Revision to a Request for a Standing Offer

Title - Sujet Black & Grey Water Flush-HMCS Ships Rinçage du système des eaux-vannes à bord des navires canadiens de Sa Majesté		
Solicitation No. - N° de l'invitation W3554-226336/A		Date 2022-09-16
Client Reference No. - N° de référence du client W3554-22-6336		Amendment No. - N° modif. 002
File No. - N° de dossier HAL-2-89008 (512)	CCC No./N° CCC - FMS No./N° VME	
GETS Reference No. - N° de référence de SEAG PW-\$HAL-512-11568		
Date of Original Request for Standing Offer		2022-08-29
Date de la demande de l'offre à commandes originale		
Solicitation Closes - L'invitation prend fin at - à 02:00 PM Atlantic Daylight Saving Time ADT on - le 2022-09-22 Heure Avancée de l'Atlantique HAA		
Address Enquiries to: - Adresser toutes questions à: Wadden, Dale		Buyer Id - Id de l'acheteur hal512
Telephone No. - N° de téléphone (782) 641-6472 ()		FAX No. - N° de FAX (902) 496-5016
Delivery Required - Livraison exigée

Solicitation amendment 002 is undertaken to:

**MECHANICAL ENGINEERING JOB INSTRUCTION (JI)
FOR
PRE-DOCKING PRESERVATION OF BLACK AND GREY WATER SYSTEM**

ANNEX B

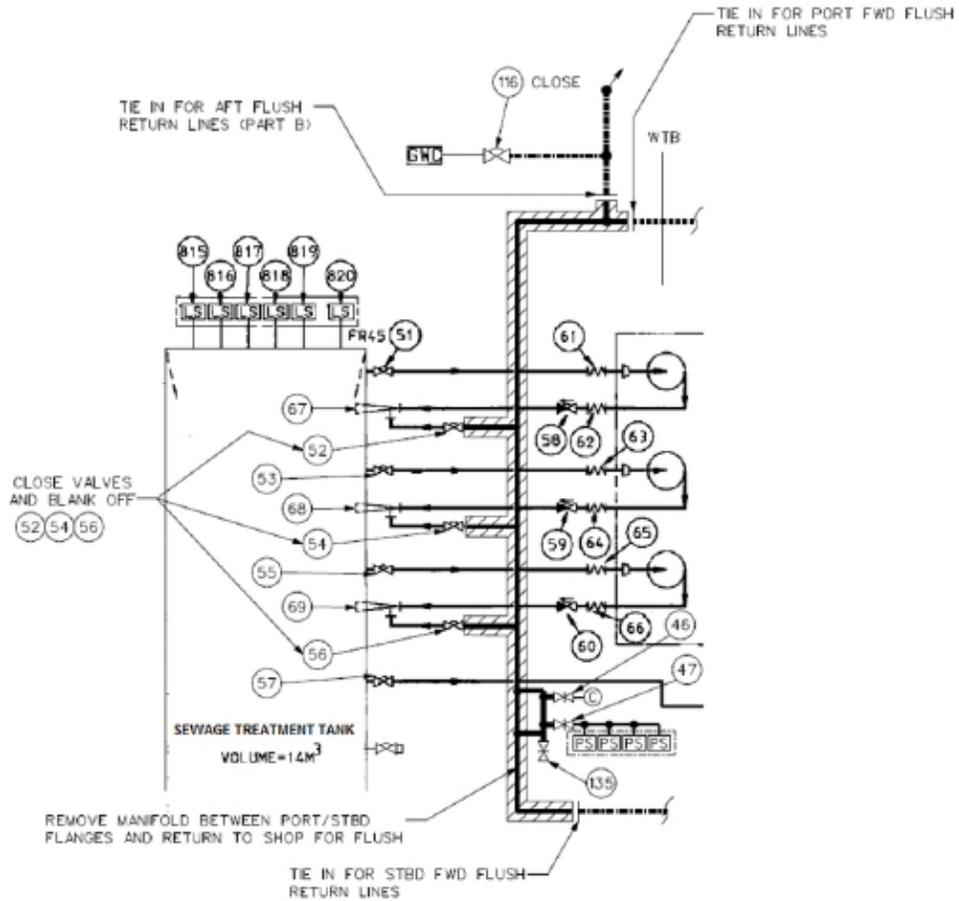
3.12	SS single point of contact shall shut down the Blackwater system prior to commencement of flush.	
3.13	Isolate the Black Water collection system from the collection tank eductors in the sewage treatment compartment at valves 52, 54, 56. Disconnect the manifold between valves 52, 54, 56 to the Port and Stbd inlet flange connections within the sewage treatment compartment. See annex B illustration.

3.13.1	Disconnect the pipe hangers holding the educator manifold.	
3.13.2	Cover all exposed piping with six-mil plastic and secure with tape.	
3.13.3	Close the gauge and pressure switch isolation valves 46, 47, 135 in the sewage treatment plant; 4 Deck, Fr 44, C/L; See illustration in annex B.

4.01.8	Cover all exposed piping with 6-mil plastic and secure with tape.	
4.01.9	Tie in for the Port Fwd flush return lines at the Port manifold flange connection, See illustration in annex B.

5.01.7	Close valve 117 to Greywater tank in the Sewage Treatment Compartment; 5 Deck, FR 43, Stbd; Ref. I. Sheet 3.	
5.01.8	Tie in for Stbd Fwd and Aft flush return lines at the manifold flange IAW illustration in annex B.
